Plan Holders of: **11th Street East Tracy Overhead Bridge Replacement Project**
CIP 73063

Subject: Addendum No. 1

ADDENDUM NO. 1

Plan Holders of: **11th Street East Tracy Overhead Bridge Replacement Project**
CIP 73063

11th ST EAST TRACY OVERHEAD
RETAINING WALLS NO. 4, NO. 5 & NO. 6 FOUNDATION PLAN

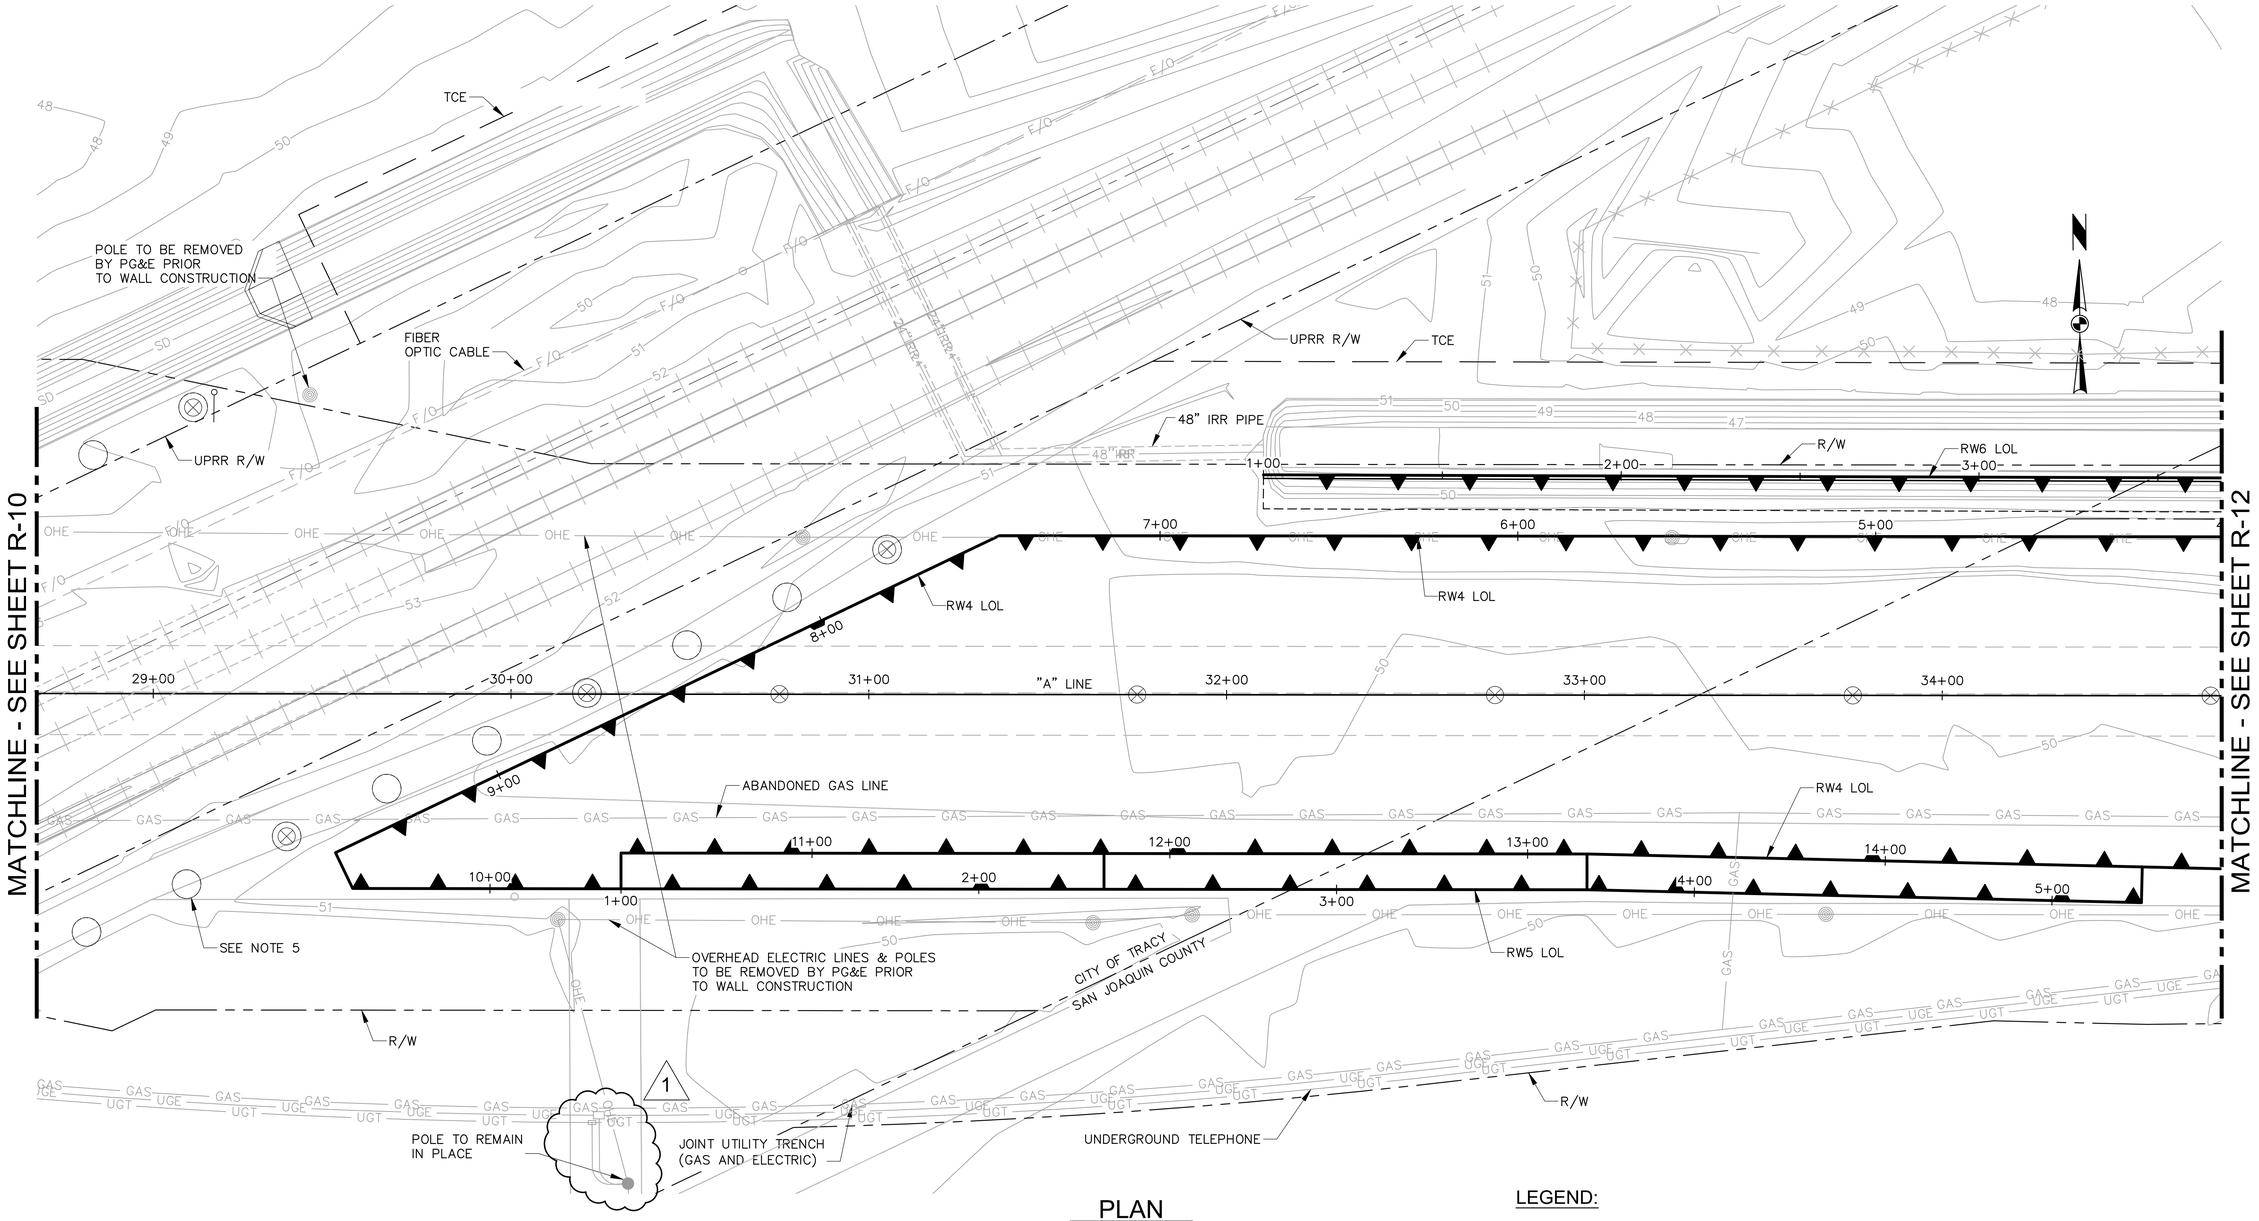
Item No. 2: **PROJECT PLANS –** Sheet 12 of 260, REMOVALS PLAN (Drawing RE-4); Sheet 46 of 260, DRAINAGE PLAN (Drawing D-4); Sheet 70 of 260, UTILITY RELOCATION STAGING PLAN (Drawing U-4); and Sheet 167 of 260, "RETAINING WALLS NO. 4, NO. 5, & NO. 6 FOUNDATION PLAN" (Drawing R-11):

- Underground telephone line modified on Drawings RE-4, D-4, U-4 and R-11
- Overhead utility line has been revised from "OHE" to "OHE&T" on Drawing U-4

RETAINING WALLS NO. 4 & NO. 6 FOUNDATION PLAN

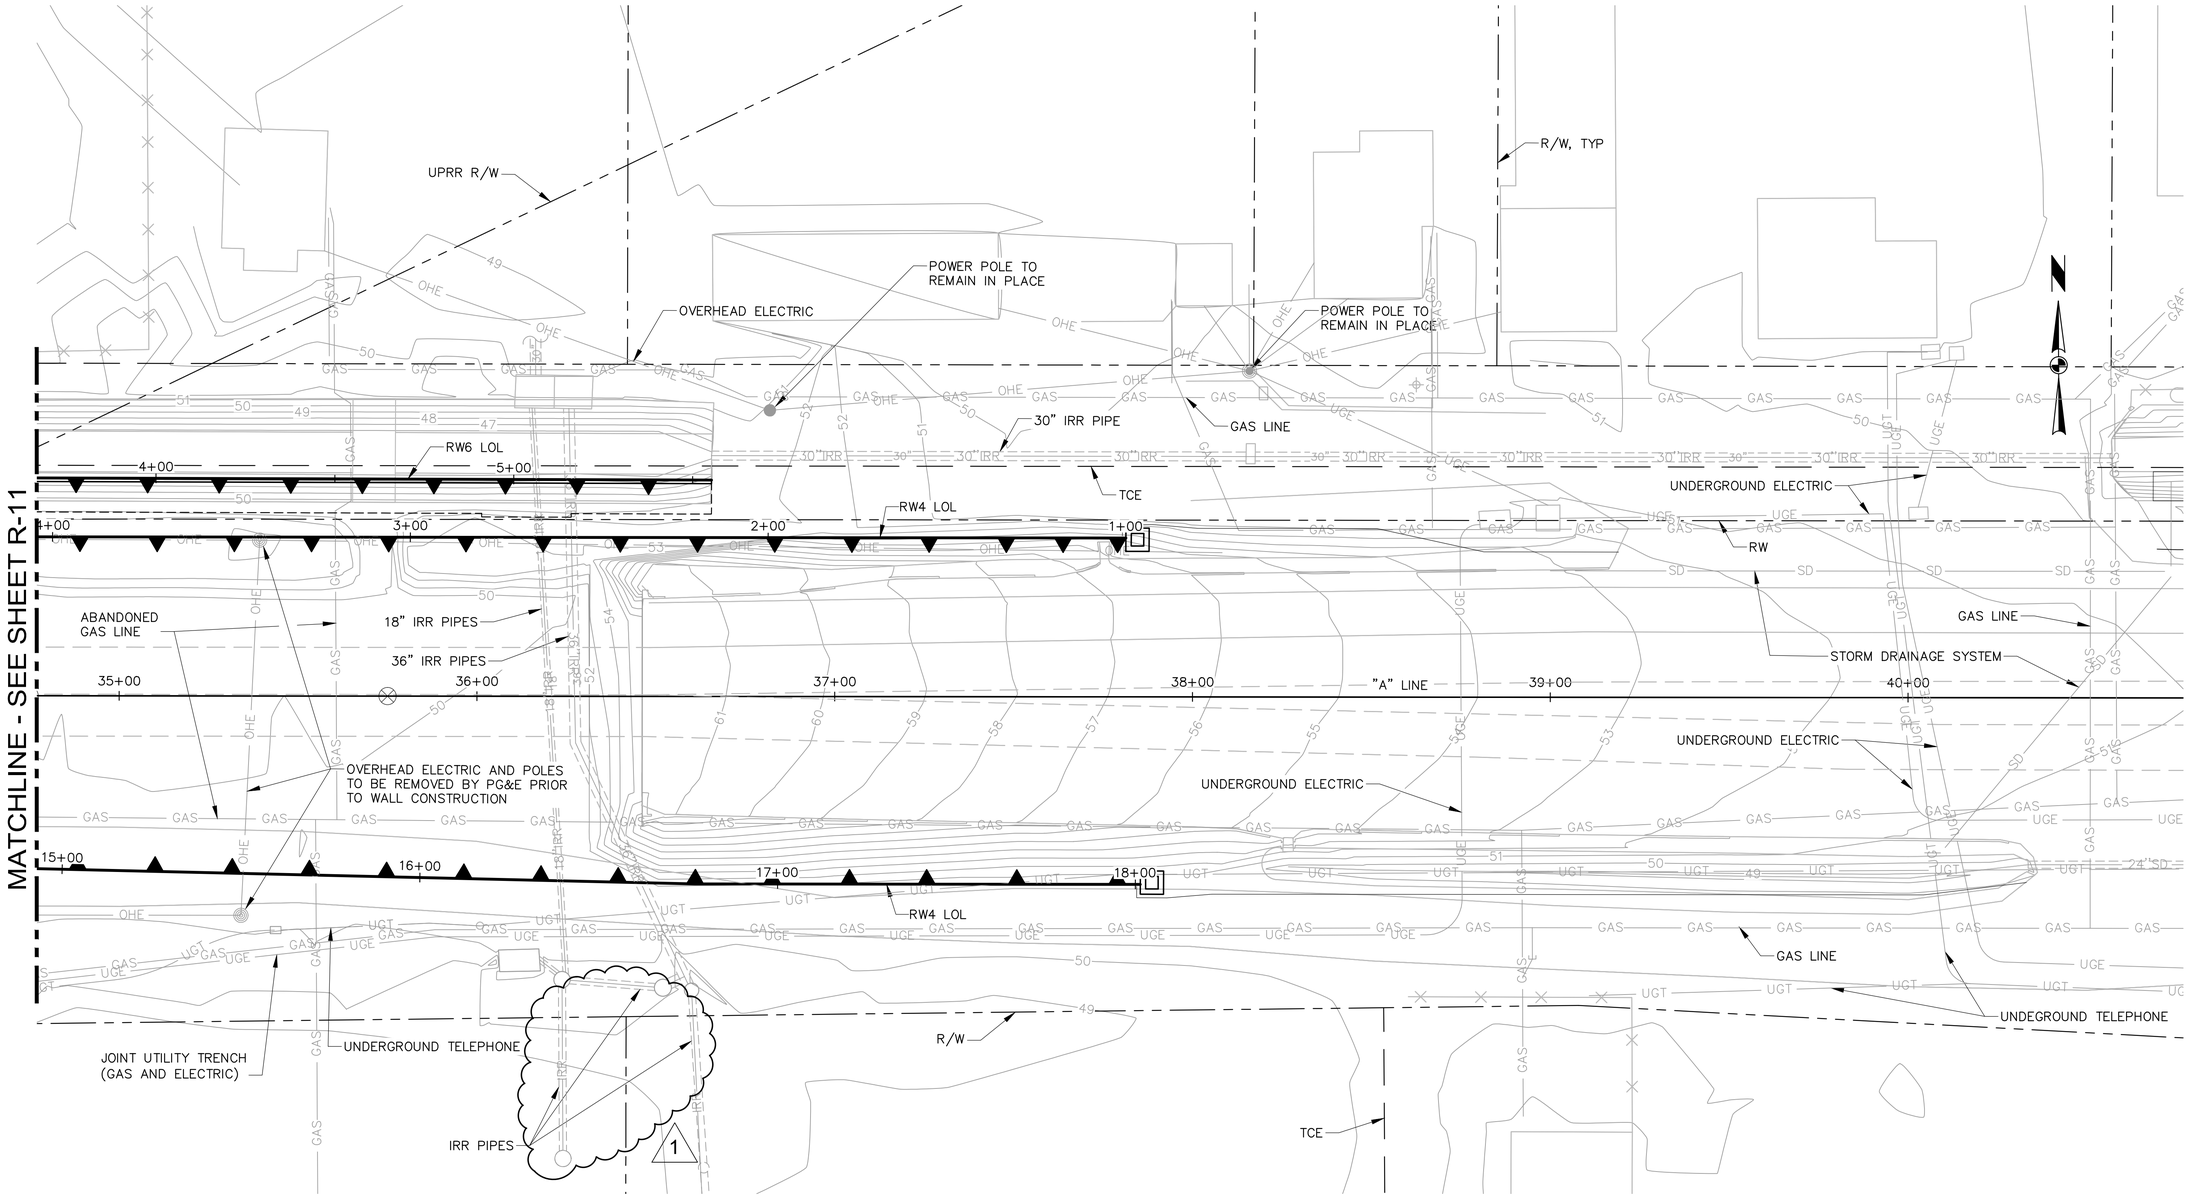
Item No. 3: **PROJECT PLANS –** Sheet 13 of 260, REMOVALS PLAN (Drawing RE-5); Sheet 19 of 260, LAYOUT (Drawing L-5); Sheet 47 of 260, DRAINAGE PLAN (Drawing D-5); Sheet 71 of 260, UTILITY RELOCATION STAGING PLAN (Drawing U-5); Sheet 79 of 260, STAGE 1 CONSTRUCTION-TRAFFIC HANDLING (Drawing SC-5); Sheet 85 of 260, STAGE 2 CONSTRUCTION-TRAFFIC HANDLING (Drawing SC-11); Sheet 91 of 260, STAGE 3 CONSTRUCTION-TRAFFIC HANDLING (Drawing SC-17); Sheet 98 of 260, STAGE 4 CONSTRUCTION-TRAFFIC HANDLING (Drawing SC-24); Sheet 105 of 260, STAGE 5 CONSTRUCTION-TRAFFIC HANDLING (Drawing SC-31); Sheet 112 of 260 STAGE 6 CONSTRUCTION-TRAFFIC HANDLING (Drawing SC-38); Sheet 124 of 260, DETOUR LAYOUT (Drawing DE-5); and Sheet 168 of 260, RETAINING WALLS NO.4, NO.5, & NO.6 FOUNDATION PLAN (Drawing R-12):

- Recently placed irrigation pipe and standpipe added
- Added irrigation ditch by others and added callouts regarding existing irrigation standpipes capped below grade and protecting existing irrigation facilities in place to Drawing U-5

CONCEPTUAL BRONZE PLAQUE ATTACHMENT DETAIL
SCALE: 3"=1'-0"

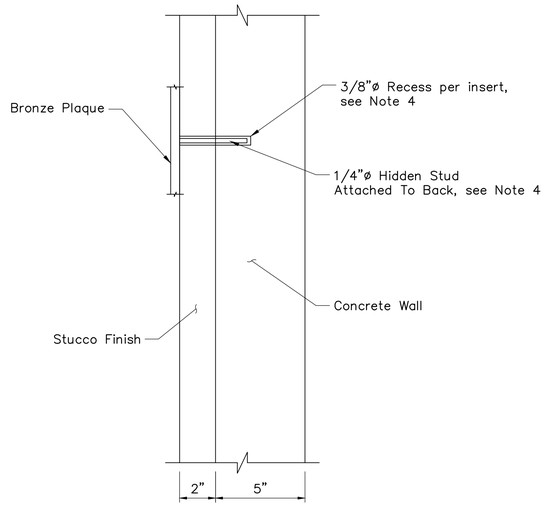
Item No. 8: **PROJECT PLANS –** Sheet 207 of 260, ENTRY MONUMENT AESTHETIC DETAILS NO. 2 (Drawing A-8):

- Added "Conceptual Bronze Plaque Attachment Details" and corresponding Note 4

S-7

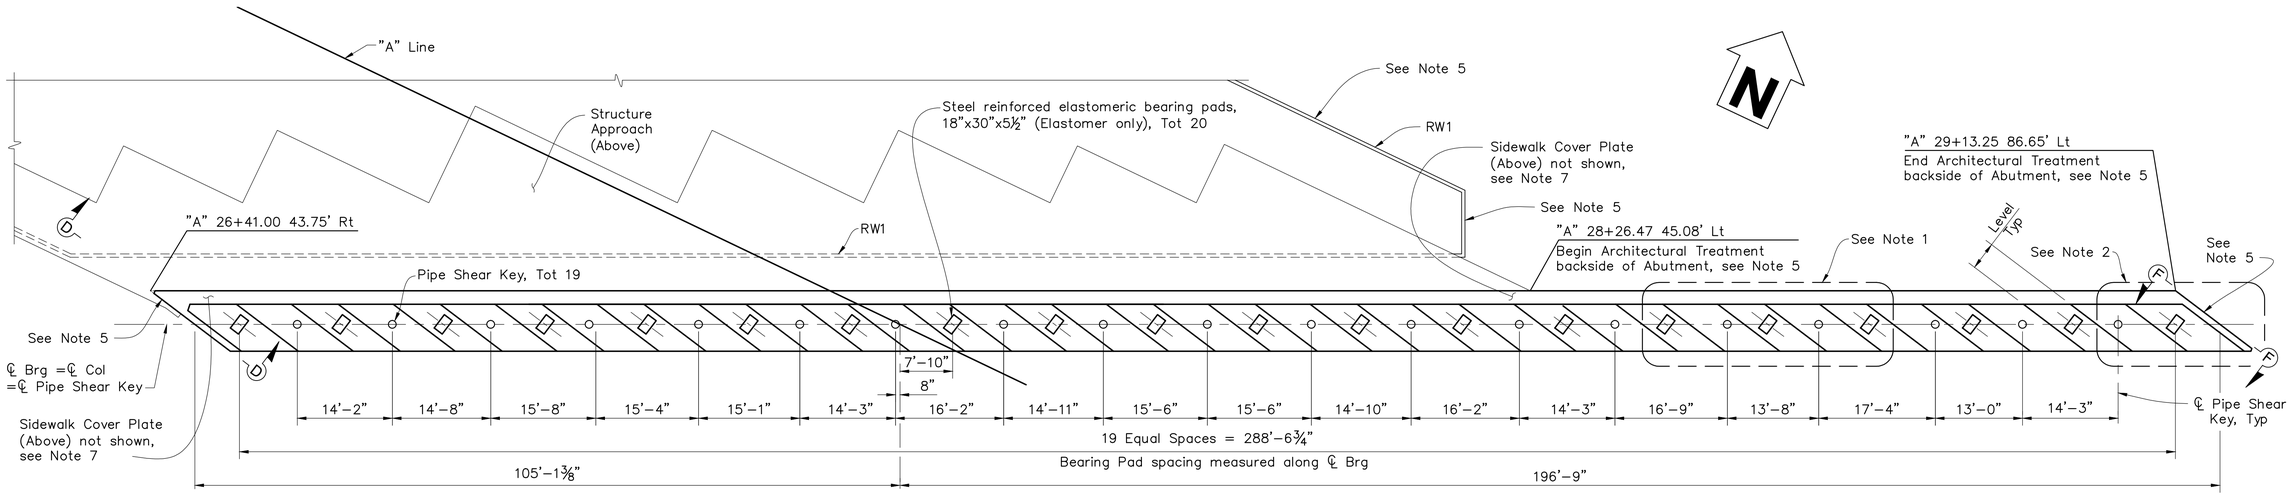
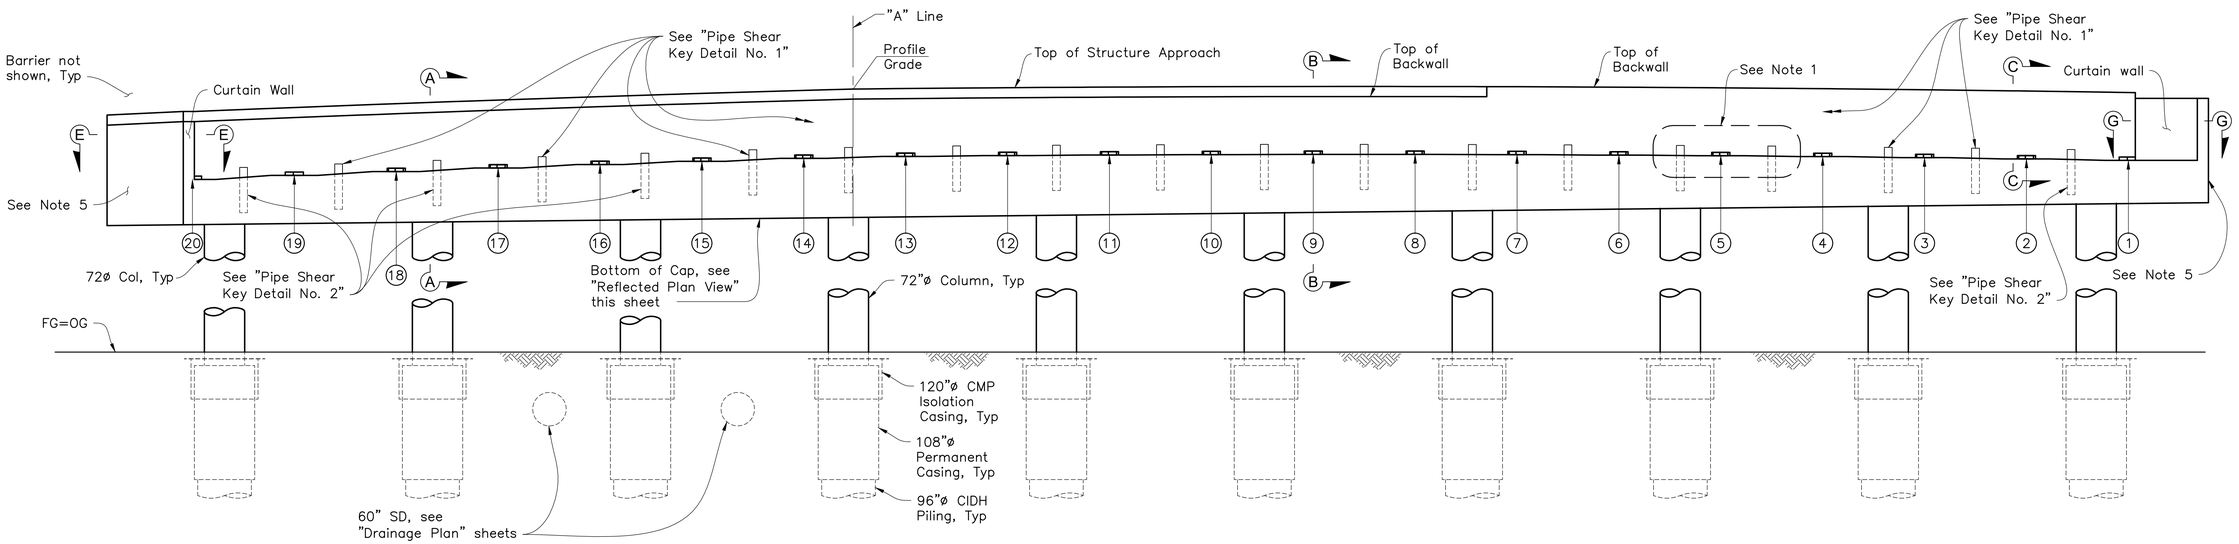
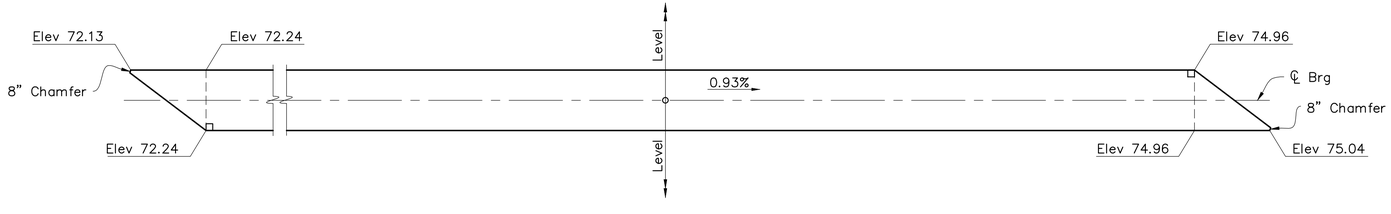
Item No. 9: **PROJECT PLANS –** Sheet 215 of 260, ABUTMENT 1 LAYOUT (Drawing S-7); Sheet 216 of 260, ABUTMENT 2 LAYOUT (Drawing S-8); Sheet 217 of 260, ABUTMENT LAYOUT DETAILS (Drawing S-9); and Sheet 222 of 260, ABUTMENT DETAILS NO 5 (Drawing S-14):

- Note 5 on Drawings S-7 & S-8 and Note 1 on Drawings S-9 and S-14 have been changed from referencing "Aesthetic Details No. 2" sheet, to correctly reference "Aesthetic Details No. 3" sheet

S-13

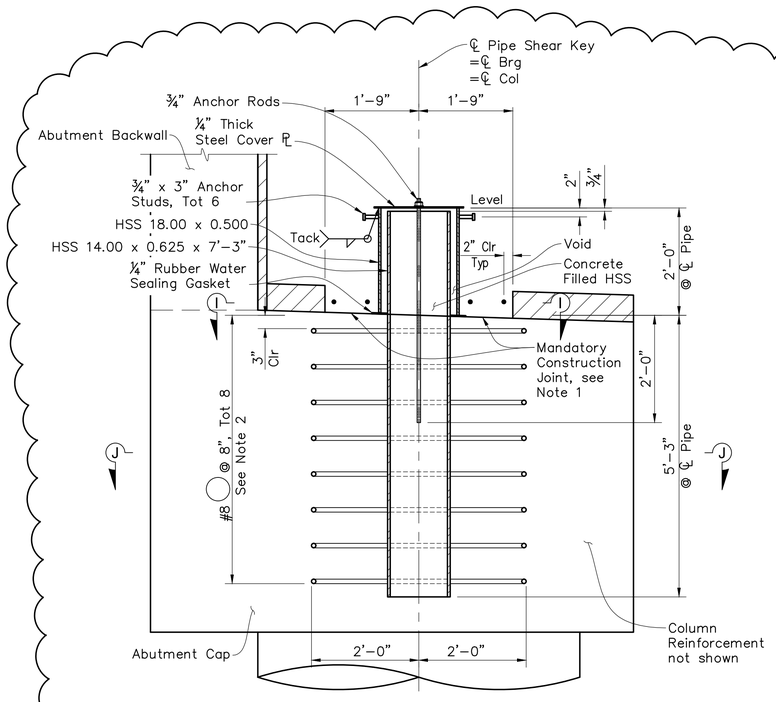
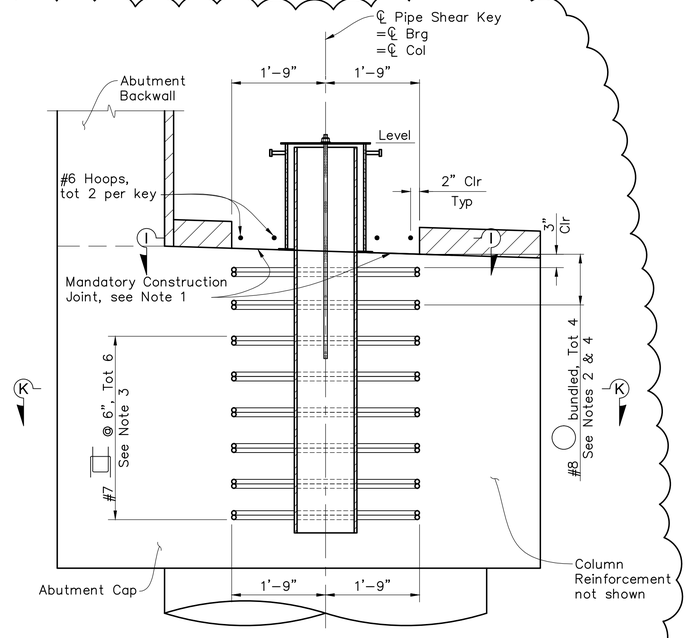
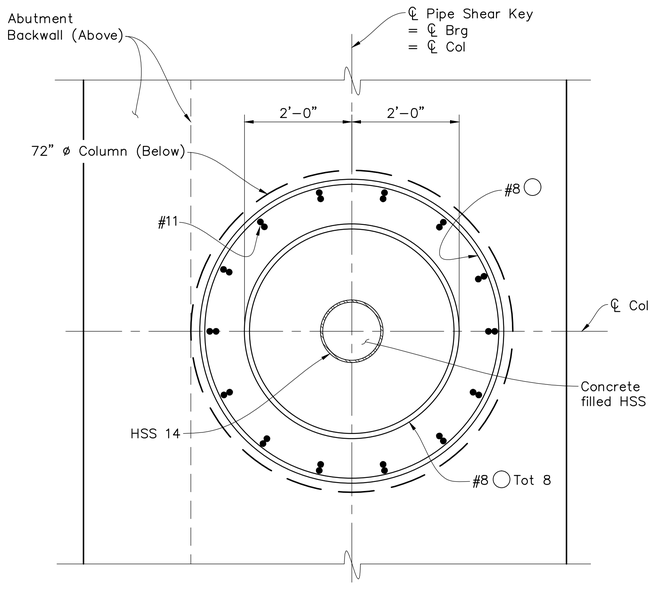
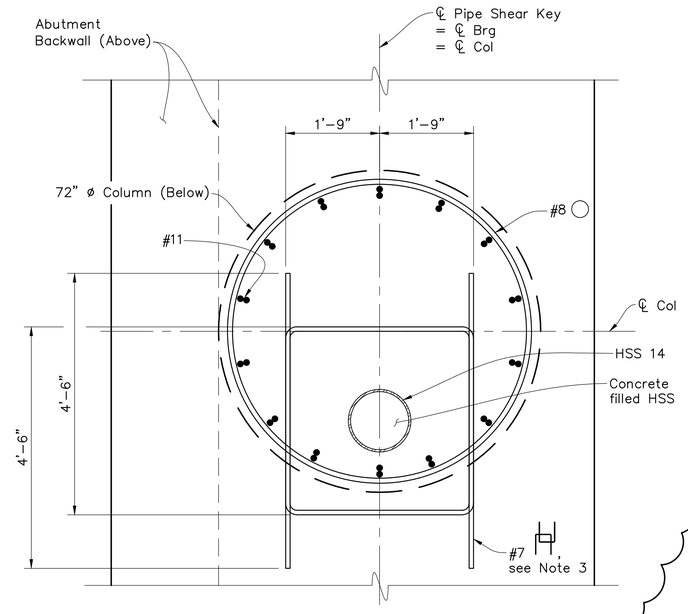
Item No. 10: **PROJECT PLANS -** Sheet 221 of 260, ABUTMENT DETAILS NO. 4 (Drawing S-13):

- Note 5 has been added
- Sections “J-J” & “K-K” scales have been increased and moved under the corresponding “Pipe Shear Key Detail”
- Sections “J-J”, “K-K”, “Pipe Shear Key Detail No. 1”, and “Pipe Shear Key Detail No. 2” have been expanded to include partial view of the abutment backwall, column, and abutment cap.
- In Section “K-K”, #7 ties and HSS 14 have been rotated to orient correctly to corresponding “Pipe Shear Key Detail No. 2”
